Wokingham Major Highways Programme - South Wokingham Distributor Road (SWDR) - Western Gateway Phase 2 (WG2)

Revised layout following planning approval and
comparison of shared use routes with LTN 1/20

Document no: WMHP-TG-WG2-RP-HI-0012

Figure 1 – Proposed shared use NMU routes in green and respective widths.

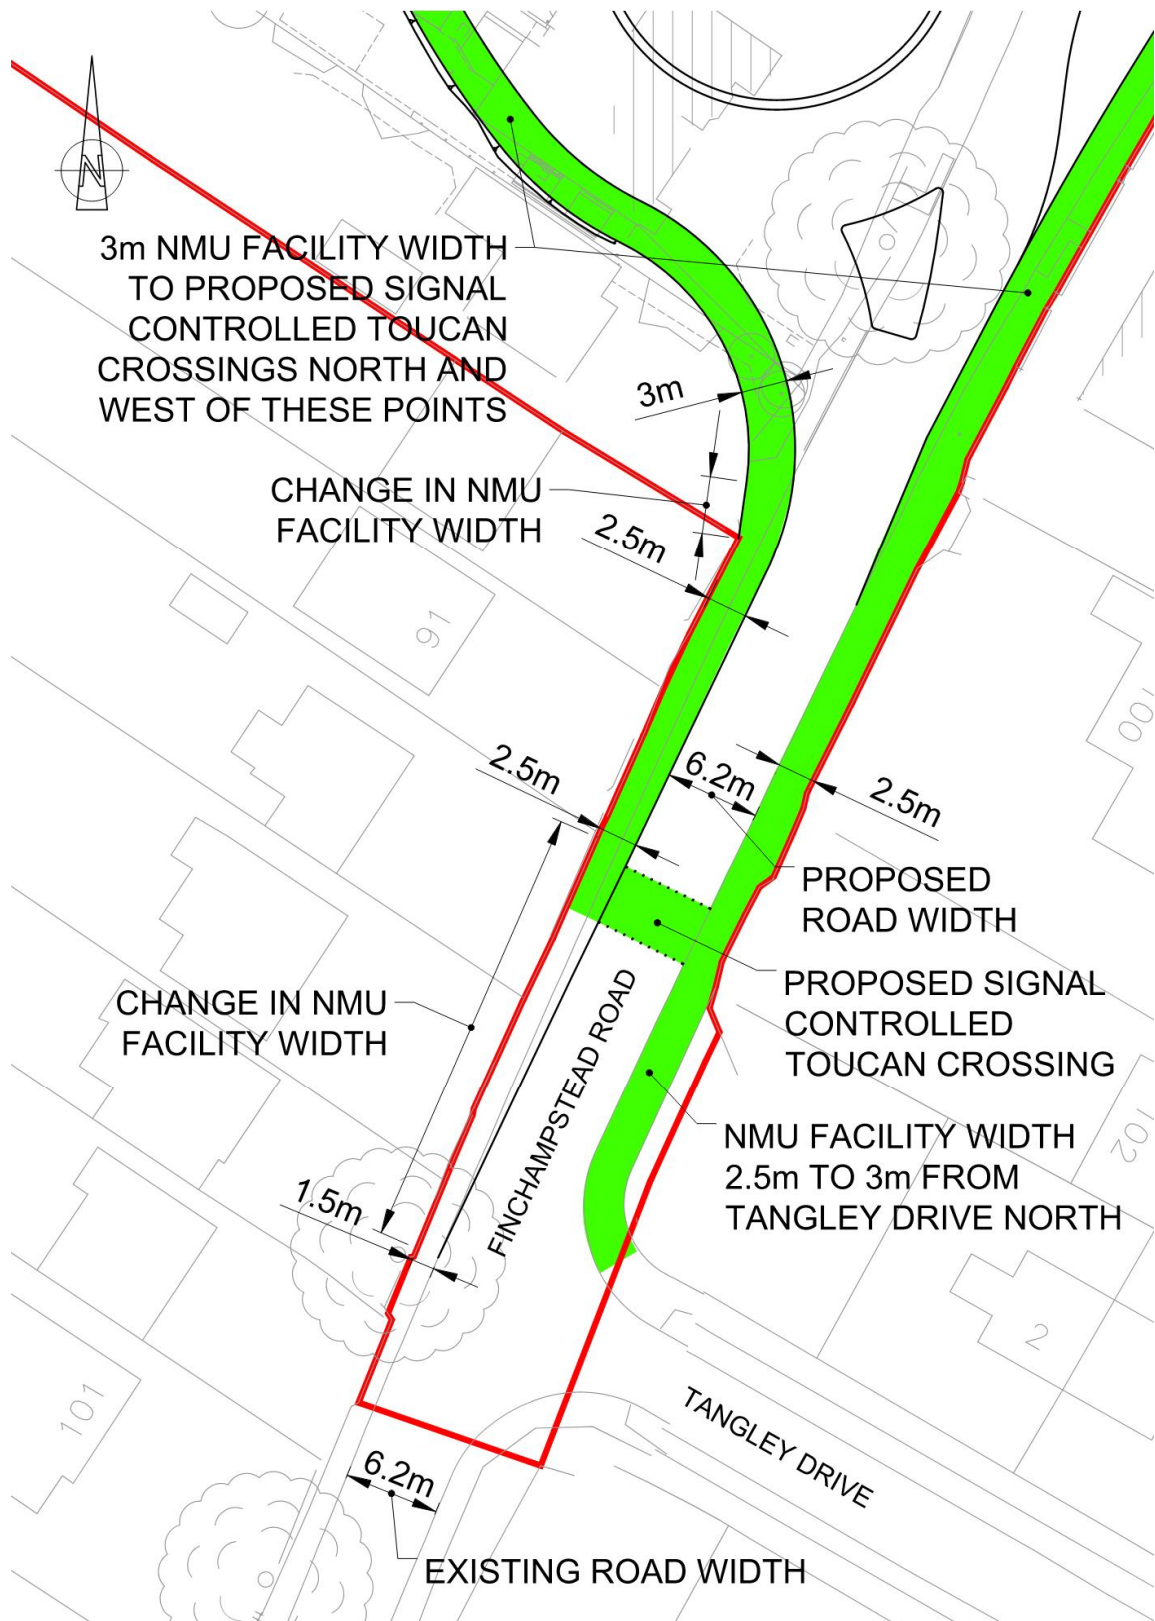
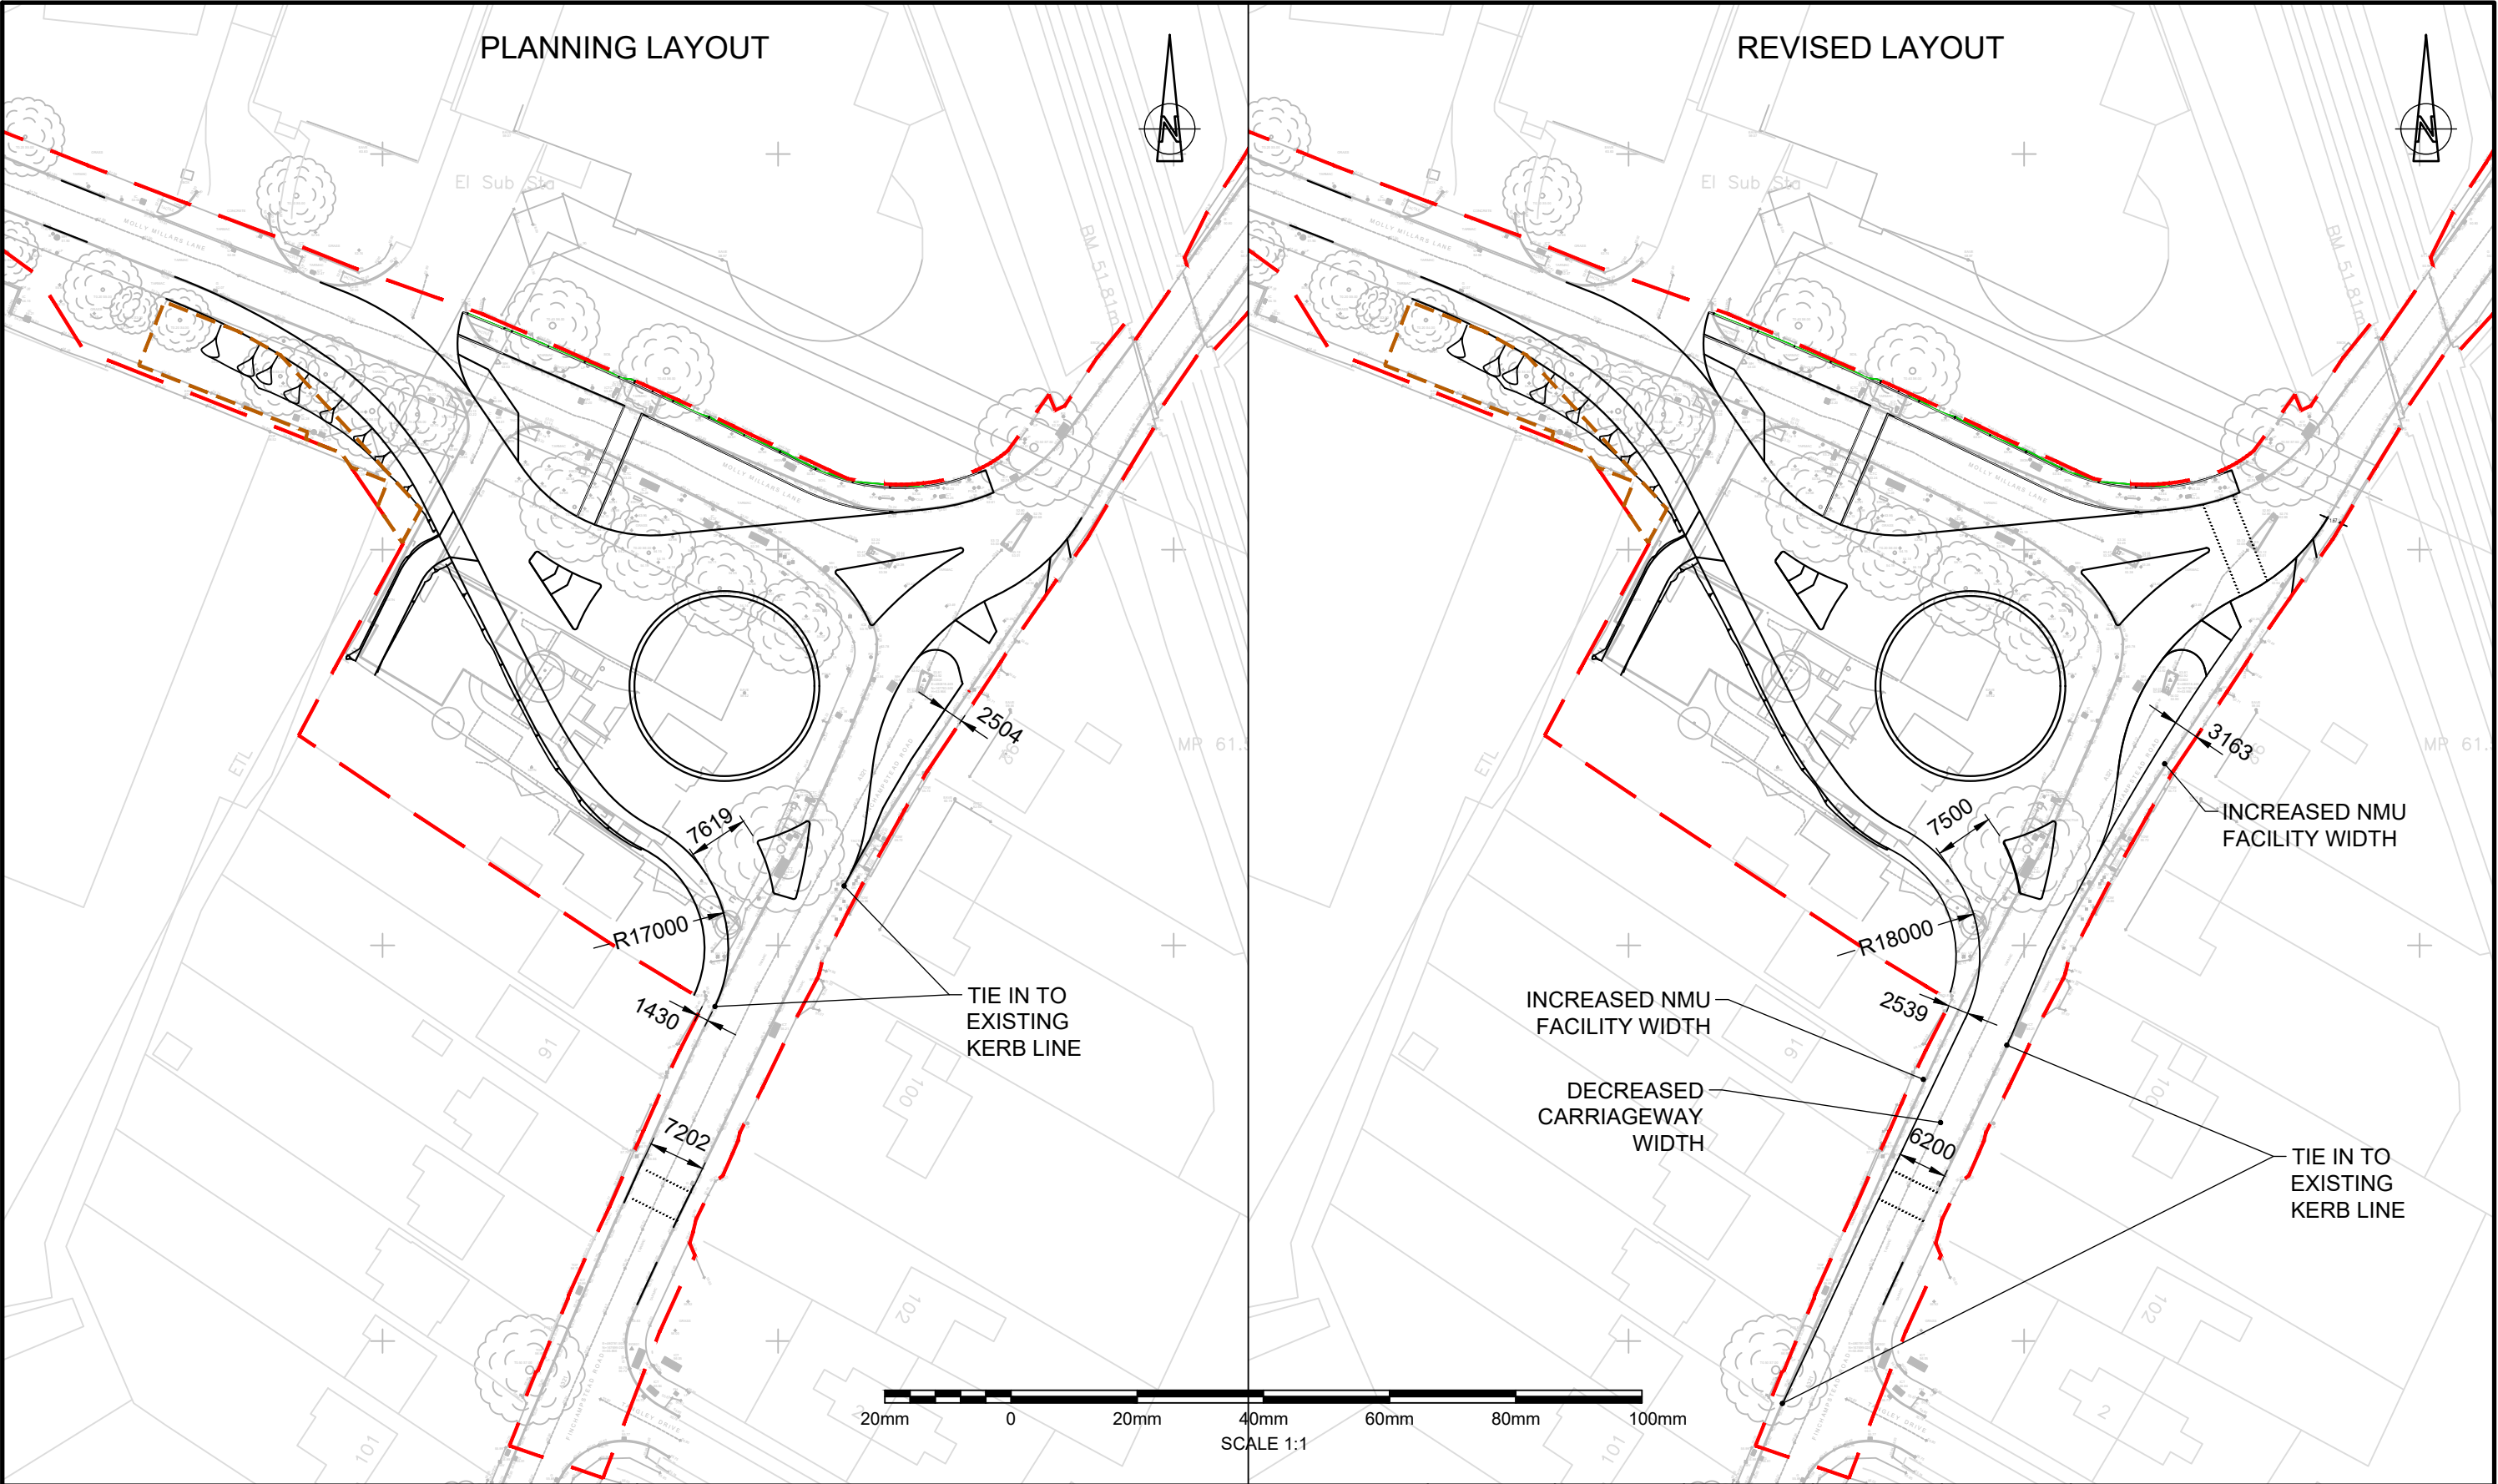
The proposed shared use NMU facilities are illustrated in Figure 1 below in green with the respective widths and commentary included for reference.

It is for these reasons that the provision within the revised layout of a minimum 2m wide effective track width (Table 5-2) with additional width of up to 0.5m for clearance where vertical objects are present (Table 5-3) and 0m to 0.5m horizontal separation (Table 6-1) resulting in a paved width of 2.5m to 3m is as per the minimum recommended values in LTN 1/20 for a shared use facility of this nature in this location with the predicted demand.
